NL-20-1273

Southern Nuclear Operating Company
Joseph M. Farley Nuclear Plant - Units 1 and 2
Edwin I. Hatch Nuclear Plant - Units 1 and 2
Vogtle Electric Generating Plant - Units 1 and 2
Vogtle Electric Generating Plant - Units 3 and 4

Response to NRC Requests for Information
License Amendment Request to Revise the Emergency Plan to Change Staffing and
Extend Staff Augmentation Times for Emergency Response Organization Positions

**Response to NRC Requests for Information
License Amendment Request to Revise Standard Emergency Plan
To Change Staffing and Extend Augmentation Times**

Figure 1

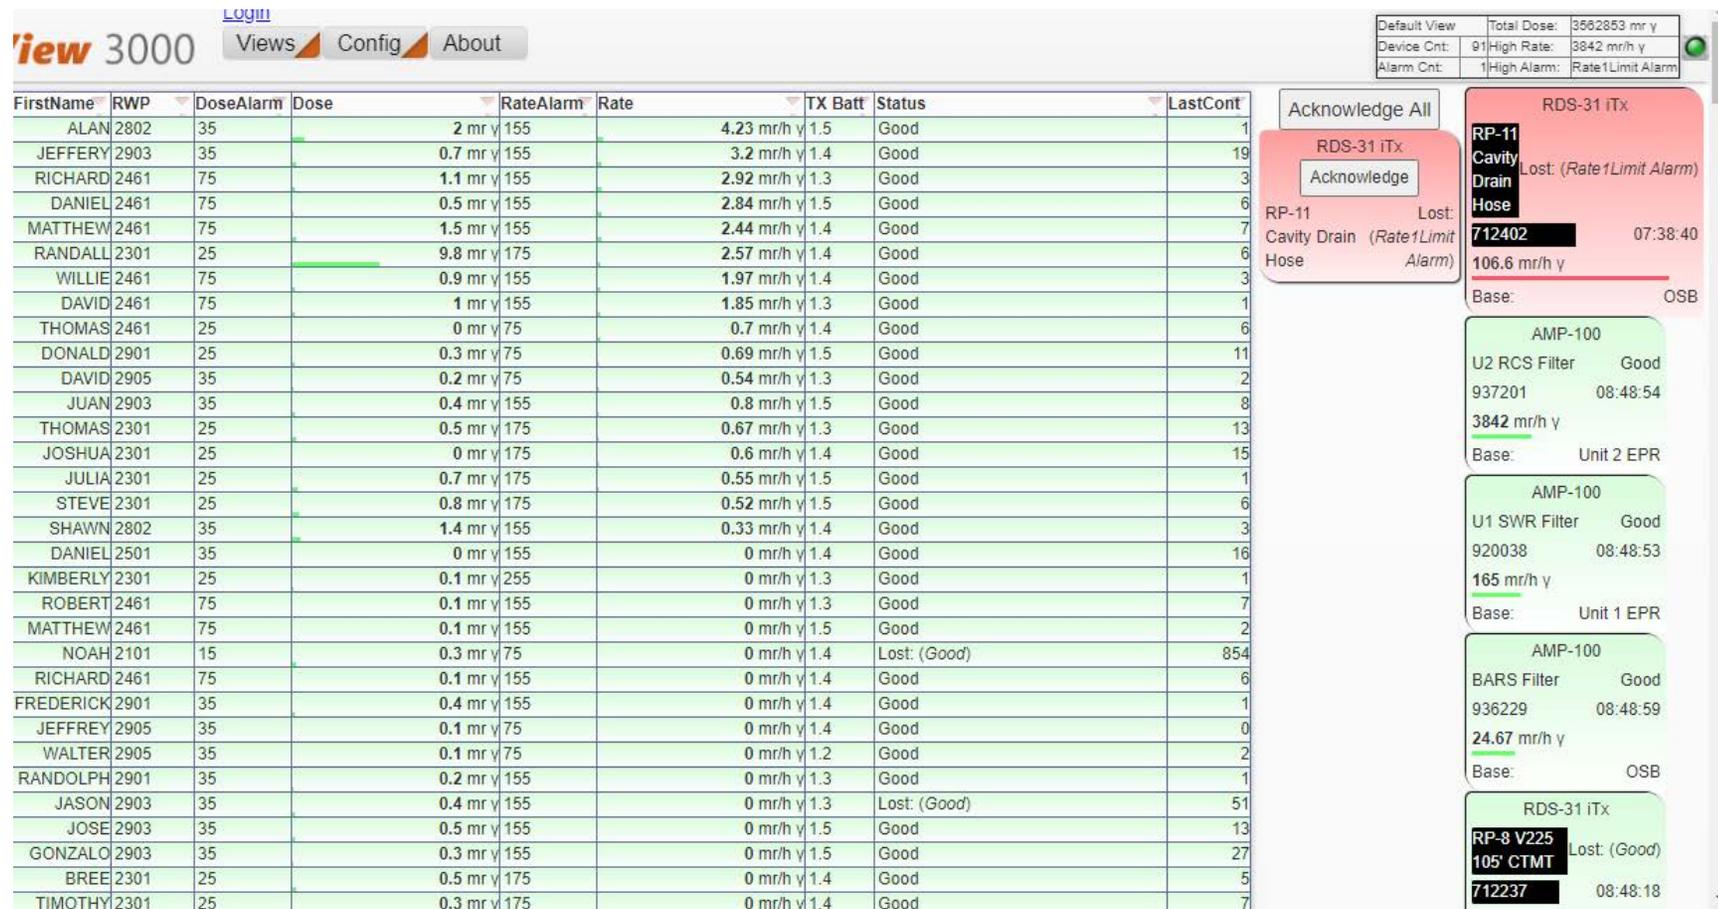
iii. Does the improved system provide the Emergency Director with dose rates for areas with key emergency plan equipment?

The plant has various installed radiation monitors that indicate dose rates on the plant computer. For example, at Farley, there is a radiation monitor in the ‘C’ Charging Pump area, which is an ECCS pump. Furthermore, SNC can deploy monitoring systems to supplement installed instrumentation. SNC is going to enhance these capabilities as part of the LAR Implementation Plan. These capabilities will provide for real-time, remote monitoring of instrumented areas. Robust monitoring of area radiation is provided by instrumentation in the field, and personnel are monitored using telemetry when needed. The information from these instruments is presented in a web-based program which is available from any company computer workstation, whether on site or remotely accessed. See Figure 1 on the next page for a screenshot example of the web-based presentation. Personnel being monitored are shown on the left side of the screen, along with the accumulated dose and dose rates. Installed radiation monitor instrumentation is shown on the right side of the screen.

The system does not rely entirely on electronic dosimetry issued to response personnel to provide indications of area dose rates. As the screenshot of the web-based dose monitoring program included above in Figure 1 demonstrates, the system uses both the telemetry issued to personnel and installed area radiation instrumentation to provide indications of dose rates.
